NOTE B:
VARIANCE FOR 3'-0" HEIGHT INCREASE SUBJECT
TO THIS APPLICATION (DRB 20-0549). ALL PLANS
AND PROJECT INFORMATION TO REMAIN AS
SUBMITTED IN PLANNING BOARD.

EIGHTEEN SUNSET
1759 PURDY AVE
MIAMI BEACH, FLORIDA
07/16/18

SOUTH ELEVATION *PROPOSED*

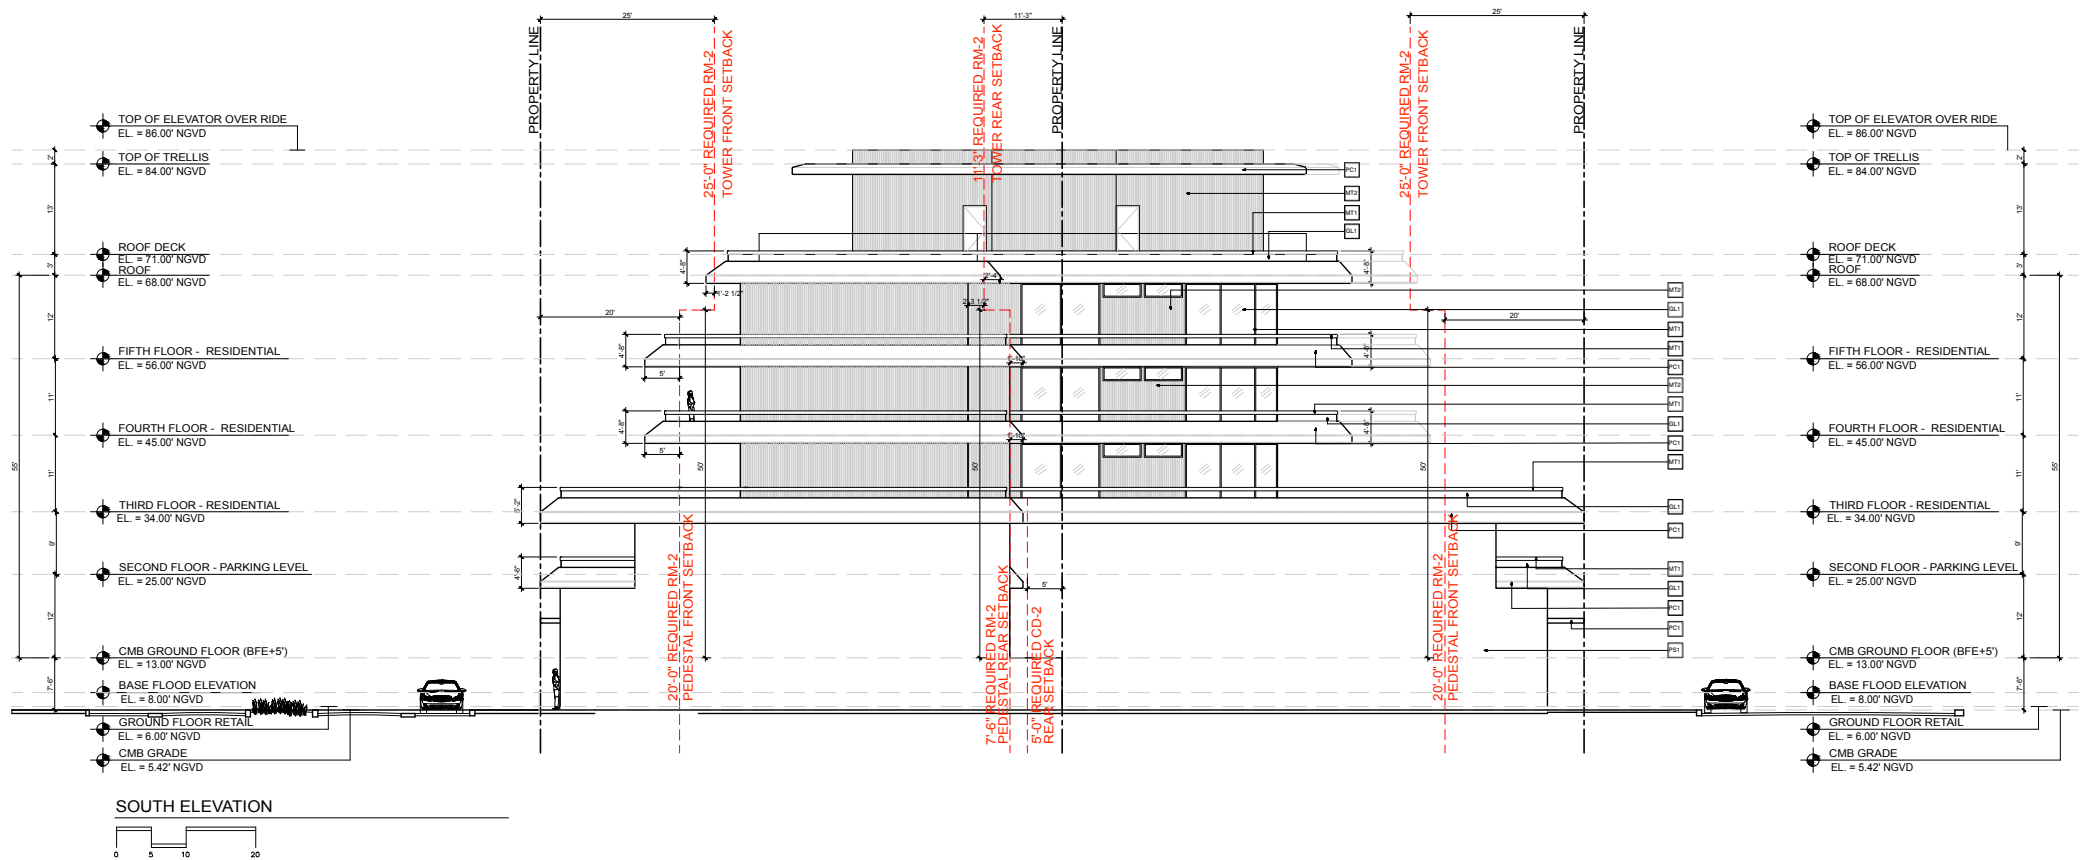
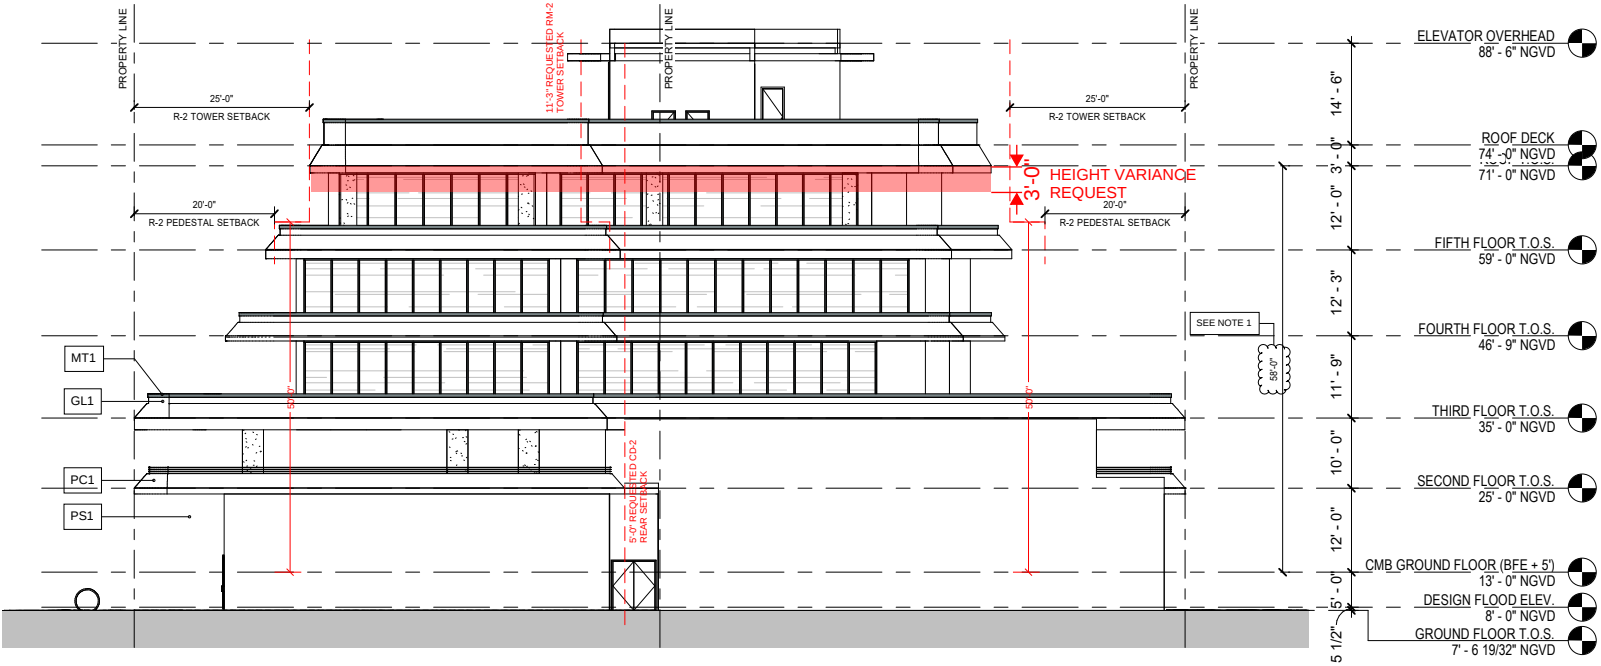
NOTE B:
VARIANCE FOR 3'-0" HEIGHT INCREASE SUBJECT TO THIS APPLICATION (DRB 20-0549). ALL PLANS AND PROJECT INFORMATION TO REMAIN AS SUBMITTED IN PLANNING BOARD.
